Access Compliance Report

Public Rights-of-Way

(Curb Ramps)

Intersection ID: 21789	Main Street: THORNCLIFF_DR	Cross Street: WOODSTOCK_DR	Location:	N
ADA ID: 4EA34D9C5A32	Ramp Type: PerpDiag	Initial Pass/Fail: Fail	Overall Compliance: No	Severity Score: 1.25
Codes/Mitigation Info/Possible Solution		Field Measurements/Component Compliance

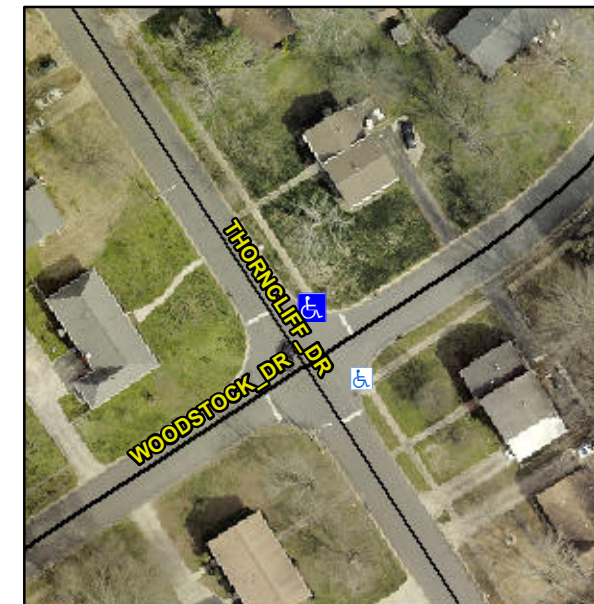
Not Found, R304.5.3

Compliance	Description	Data	Compliance	Description	Data
N/A	Ramp Length (in)	40.0	Yes	Ramp Slope (%)	7.2
Yes	Ramp Width (in)	55.0	No	Ramp XSlope (%)	3.1
N/A	Flare Type LT	N/A	N/A	Flare Type RT	N/A
N/A	Flare Slope LT (%)	N/A	N/A	Flare Slope RT (%)	N/A
N/A	Flare Traversable LT?	N/A	N/A	Flare Traversable RT?	N/A
N/A	Landing Length (in)	N/A	N/A	DWS Provided?	N/A
N/A	Landing Width (in)	N/A	N/A	DWS Contrast?	N/A
N/A	Landing Slope (%)	N/A	N/A	DWS Length (in)	N/A
N/A	Landing X Slope (%)	N/A	N/A	DWS Full Width?	N/A
N/A	Landing Curb? (Y/N)	N/A	N/A	DWS Offset (in)	N/A
N/A	Shared Landing?	N/A			
N/A	Gutter Ponding?	N/A	N/A	Gutter Slope (%)	N/A
N/A	Gutter Lip Ht (in)	N/A	N/A	Gutter X Slope (%)	N/A
N/A	Painted X Walk1?	No	N/A	Painted X Walk2?	No
	X Walk 1 Direction	To SW		X Walk 2 Direction	To SE
N/A	X Walk 1 Width (in)	N/A	N/A	X Walk 2 Width (in)	N/A
	X Walk 1 Slope (%)	4.2		X Walk 2 Slope (%)	0.9
	X Walk 1 X Slope (%)	0.2		X Walk 2 X Slope (%)	3.4

Remove & Replace Curb Ramp With Two New Directional Ramps or Equivalent.
